# **ATTACHMENT B**

## **PROPOSED CHANGES TO APPENDIX A**

### **TECHNICAL SPECIFICATIONS**

## **FIGURE 3.6.1 FOR DRESDEN UNITS 2 AND 3**

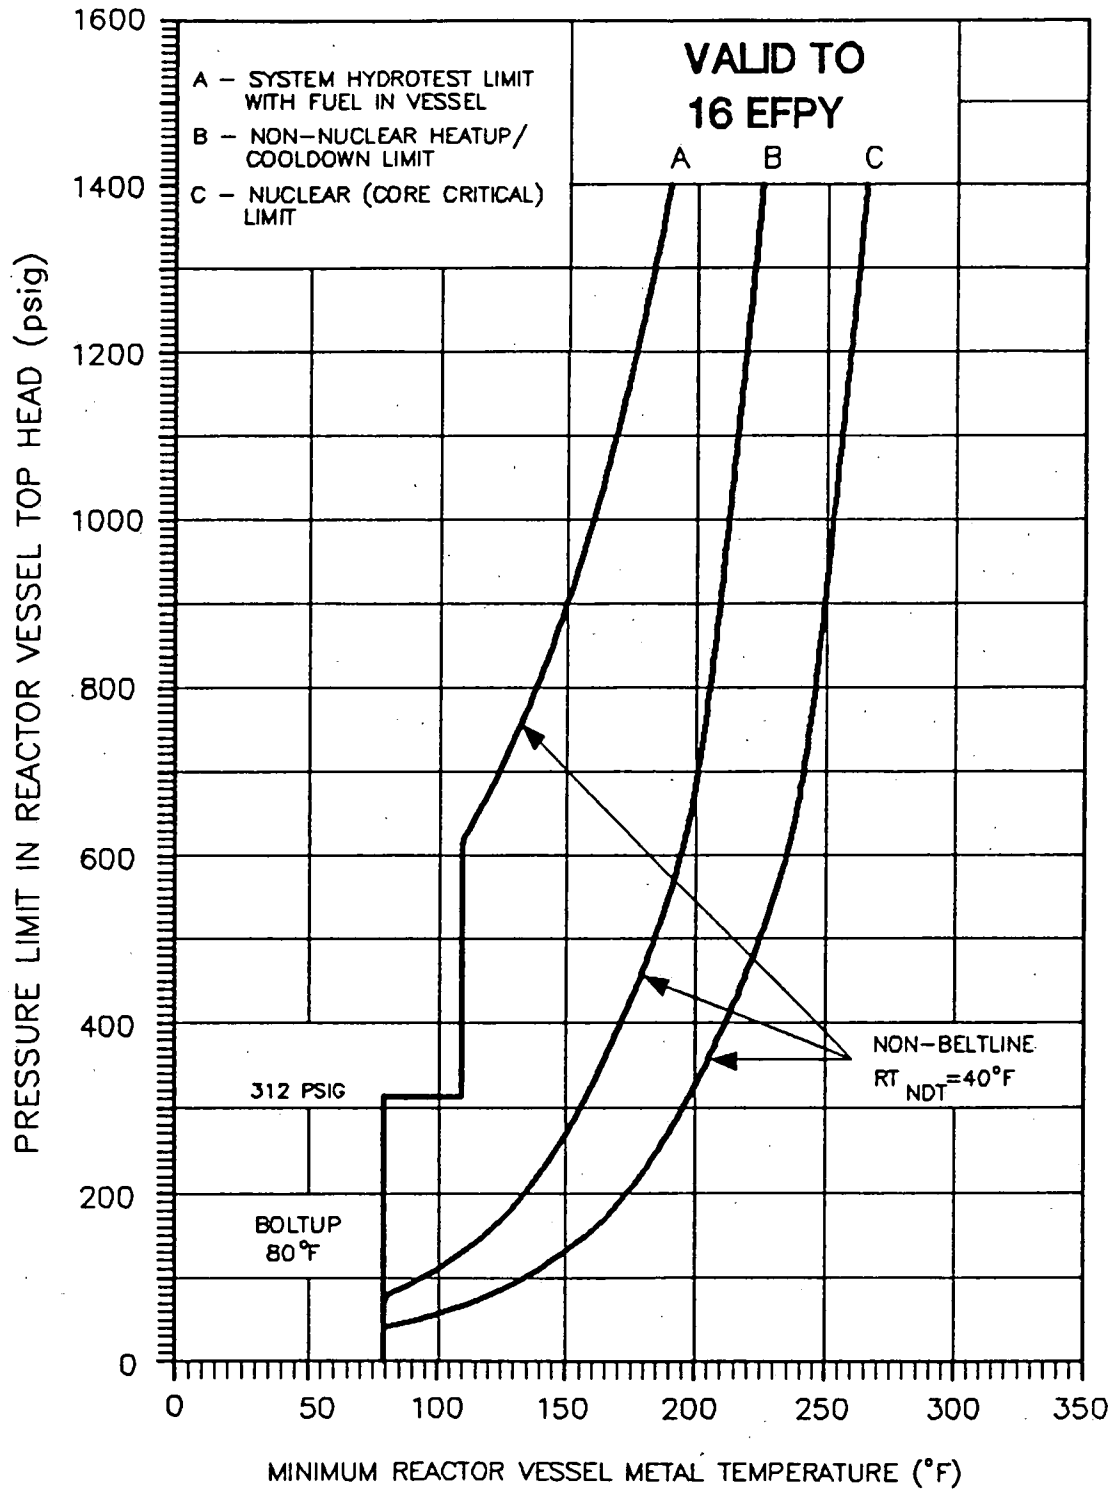
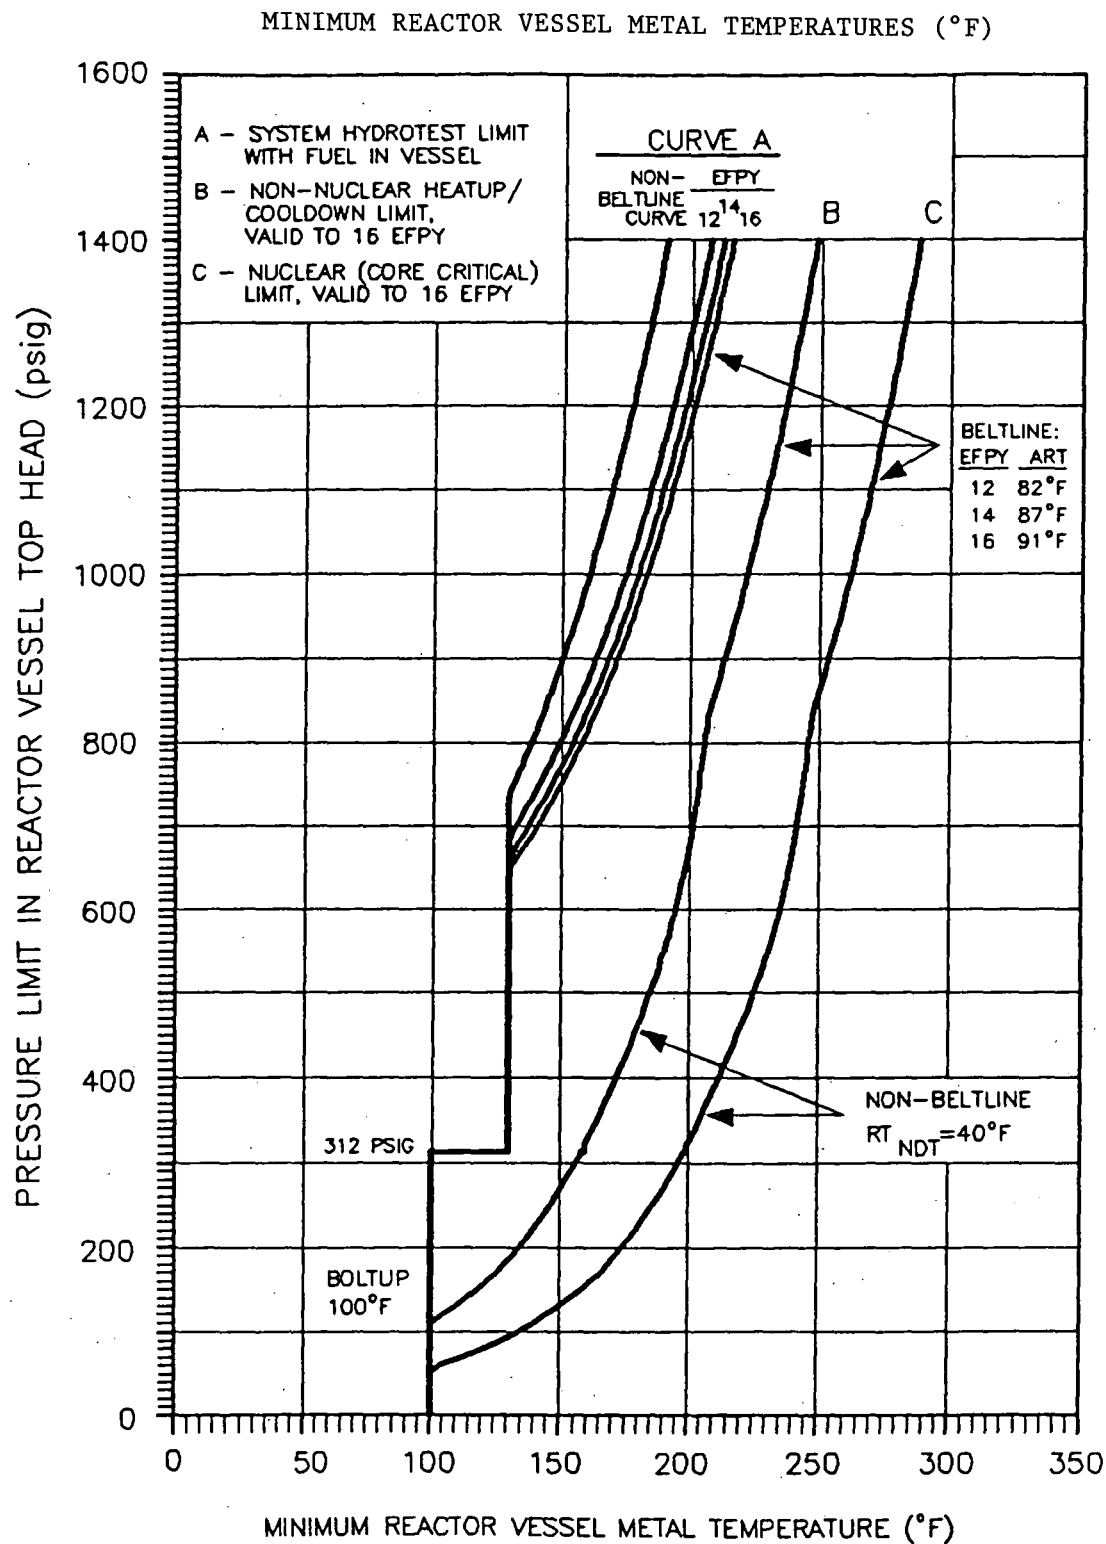
As indicated in Curve A of Figure 3.6.1 for system hydrotesting, the minimum metal temperature of the reactor vessel shell is 80°F for reactor pressures less than 312 psig. This 80°F minimum boltup temperature is based on a  $RT_{NDT}$  of 20°F for the top head plate (most limiting material) and a 60°F conservatism required by the original ASME Code of construction.

At reactor pressures greater than 312 psig the minimum vessel metal temperature is established as 110°F. The 110°F minimum temperature is based on a closure flange region  $RT_{NDT}$  of 20°F and a 90°F conservatism required by 10 CFR 50 Appendix G for pressure in excess of 20% of the preservice hydrostatic test pressure (1563 psig).

At approximately 620 psig reactor pressure the effects of pressurization become more limiting than the boltup stresses at the closure flange region, as shown by the non-linear portion of Curve A intersecting the vertical 110°F line. The non-linear portion of the curve is dependent on the non-beltline region (which is actually more limiting than the beltline region through a vessel exposure of 22 effective full power years), and based on a  $RT_{NDT}$  of 40°F.

Curve B of Figure 3.6.1 applies during heatups with non-nuclear heat (e.g. recirculation pump heat) and during cooldowns when the reactor is not critical (e.g. following a scram). The curve provides the minimum reactor vessel metal temperatures based on the most limiting vessel stress (non-beltline stresses).

As indicated by the vertical 80°F line, the boltup stresses at the closure flange region are most limiting below approximately 80 psig. Above approximately 80 psig, pressurization and thermal stresses become more limiting than the boltup stresses, which is reflected by the non-linear portion of Curve B. The non-linear portion of the curve is dependent on the non-beltline region (which is actually more limiting than the beltline region through a vessel exposure of 22 effective full power years), and based on a  $RT_{NDT}$  of 40°F.

Curve C, the core critical operation curve shown in Figure 3.6.1, is generated in accordance with 10 CFR 50 Appendix G which requires core critical pressure-temperature limits to be 40°F above any Curve A or B limits. Since Curve B is more limiting, Curve C is Curve B plus 40°F.

FIGURE 3.6-1

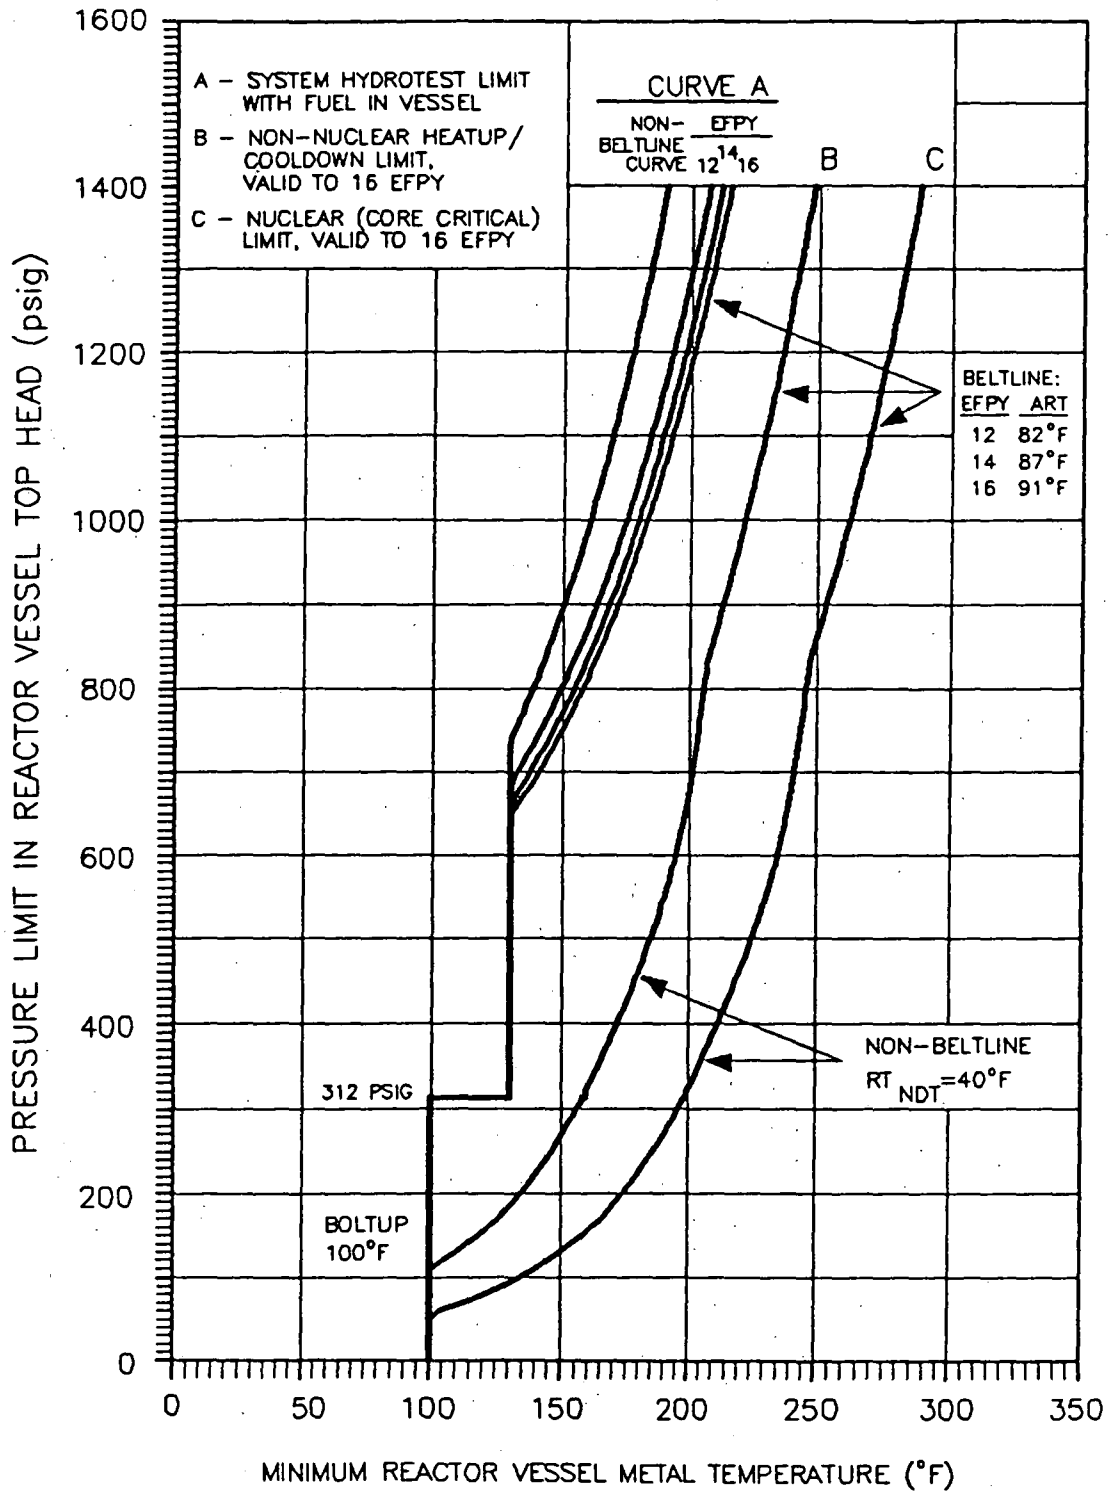
As indicated in Curve A of Figure 3.6-1 for system hydrotesting, the minimum metal temperature of the reactor vessel shell is 100°F for reactor pressures less than 312 psig. This 100°F minimum boltup temperature is based on a  $RT_{NDT}$  of 40°F for the electrosag weld immediately below the vessel flange and a 60°F conservatism required by the original ASME Code of construction.

At reactor pressures greater than 312 psig the minimum vessel metal temperature is established as 130°F. The 130°F minimum temperature is based on a closure flange region  $RT_{NDT}$  of 40°F and a 90°F conservatism required by 10 CFR 50 Appendix G for pressure in excess of 20% of the preservice hydrostatic test pressure (1563 psig).

At approximately 650 psig the effects of pressurization are more limiting than the boltup stresses at the closure flange region, hence a family of non-linear curves intersect the 130°F vertical line. Beltline as well as non-beltline curves have been provided to allow separate monitoring of the two regions. Beltline curves as a function of vessel exposure for 12, 14 and 16 effective full power years (EFPY) are presented to allow the use of the appropriate curve up to 16 EFPY of operation.

Curve B of Figure 3.6-1 applies during heatups with non-nuclear heat (e.g., recirculation pump heat) and during cooldowns when the reactor is not critical (e.g., following a scram). The curve provides the minimum reactor vessel metal temperatures based on the most limiting vessel stress.

As indicated by the vertical 100°F line, the boltup stresses at the closure flange region are most limiting for reactor pressures below approximately 110 psig. For reactor pressures greater than approximately 110 psig, pressurization and thermal stresses become more limiting than the boltup stresses, which is reflected by the non-linear portion of Curve B. The non-linear portion of the curve is dependent on non-beltline and beltline regions, with the beltline region temperature limits having been adjusted to account for vessel irradiation (up to a vessel exposure of 16 EFPY). The non-beltline region is limiting between approximately 110 psig and 830 psig. Above approximately 830 psig, the beltline region becomes limiting.

Curve C, the core critical operation curve shown in Figure 3.6-1, is generated in accordance with 10 CFR 50 Appendix G which requires core critical pressure-temperature limits to be 40°F above any Curve A or B limits. Since Curve B is more limiting, Curve C is Curve B plus 40°F.

FIGURE 3.6-1

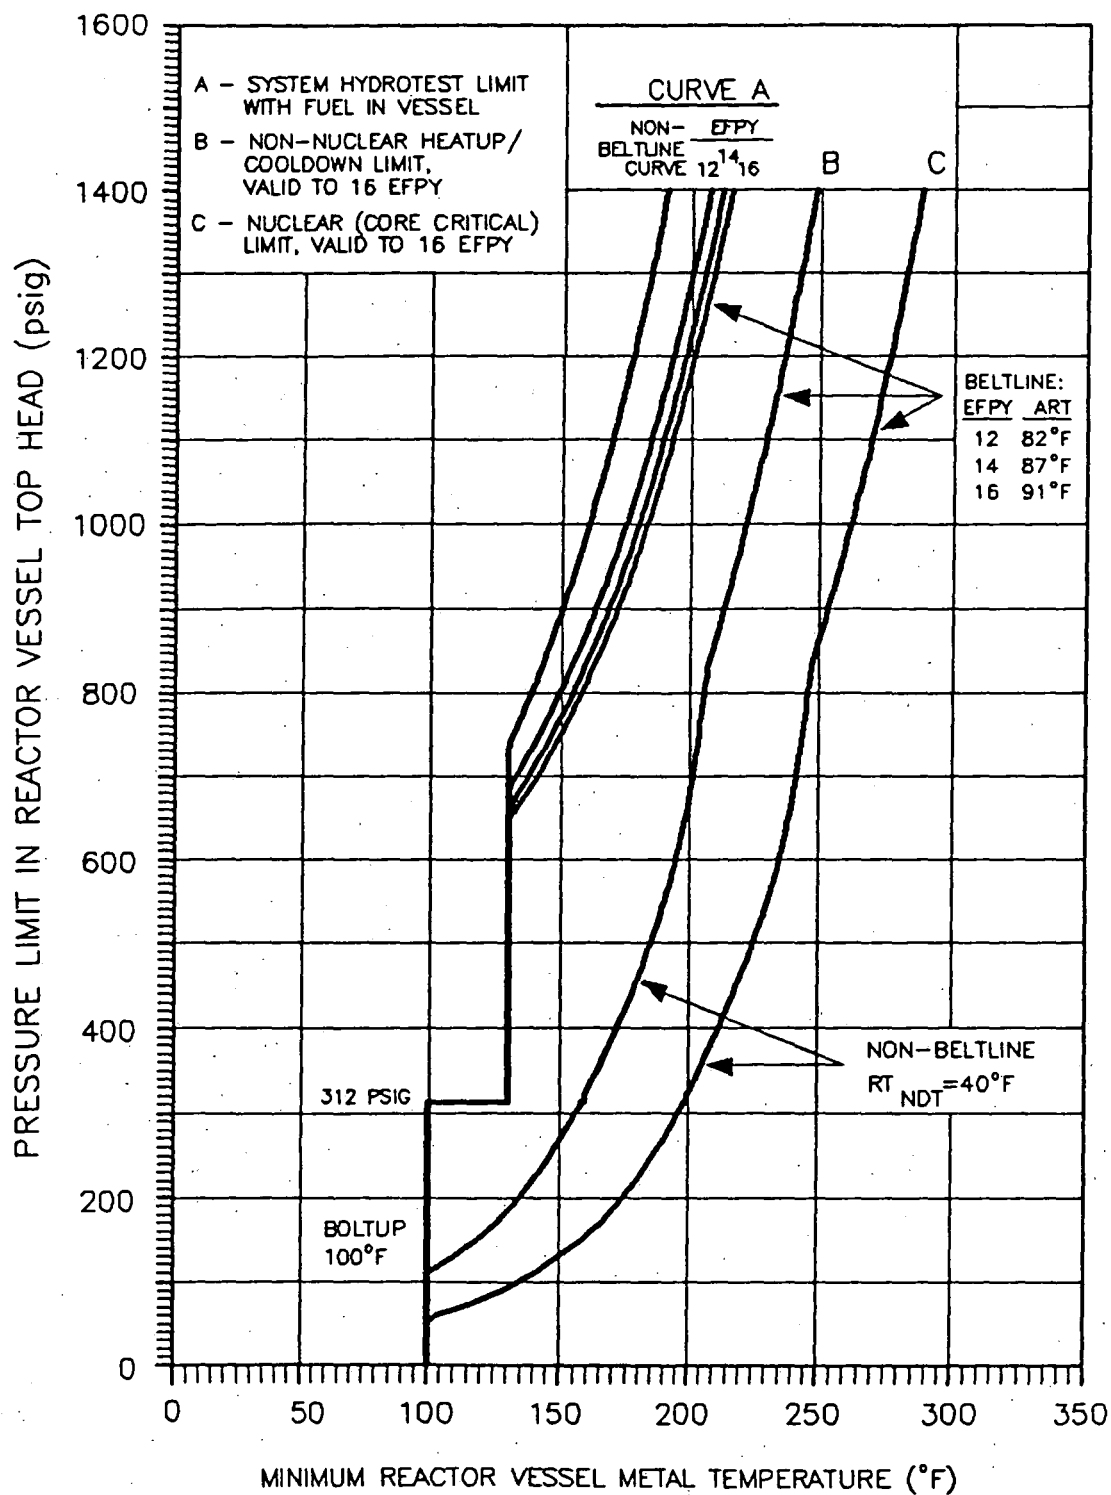
As indicated in Curve A of Figure 3.6-1 for system hydrotesting, the minimum metal temperature of the reactor vessel shell is 100°F for reactor pressures less than 312 psig. This 100°F minimum boltup temperature is based on a  $RT_{NDT}$  of 40°F for the electrosag weld immediately below the vessel flange and a 60°F conservatism required by the original ASME Code of construction.

At reactor pressures greater than 312 psig the minimum vessel metal temperature is established as 130°F. The 130°F minimum temperature is based on a closure flange region  $RT_{NDT}$  of 40°F and a 90°F conservatism required by 10 CFR 50 Appendix G for pressure in excess of 20% of the preservice hydrostatic test pressure (1563 psig).

At approximately 650 psig the effects of pressurization are more limiting than the boltup stresses at the closure flange region, hence a family of non-linear curves intersect the 130°F vertical line. Beltline as well as non-beltline curves have been provided to allow separate monitoring of the two regions. Beltline curves as a function of vessel exposure for 12, 14 and 16 effective full power years (EFPY) are presented to allow the use of the appropriate curve up to 16 EFPY of operation.

Curve B of Figure 3.6-1 applies during heatups with non-nuclear heat (e.g., recirculation pump heat) and during cooldowns when the reactor is not critical (e.g., following a scram). The curve provides the minimum reactor vessel metal temperatures based on the most limiting vessel stress.

As indicated by the vertical 100°F line, the boltup stresses at the closure flange region are most limiting for reactor pressures below approximately 110 psig. For reactor pressures greater than approximately 110 psig, pressurization and thermal stresses become more limiting than the boltup stresses, which is reflected by the non-linear portion of Curve B. The non-linear portion of the curve is dependent on non-beltline and beltline regions, with the beltline region temperature limits having been adjusted to account for vessel irradiation (up to a vessel exposure of 16 EFPY). The non-beltline region is limiting between approximately 110 psig and 830 psig. Above approximately 830 psig, the beltline region becomes limiting.

Curve C, the core critical operation curve shown in Figure 3.6-1, is generated in accordance with 10 CFR 50 Appendix G which requires core critical pressure-temperature limits to be 40°F above any Curve A or B limits. Since Curve B is more limiting, Curve C is Curve B plus 40°F.
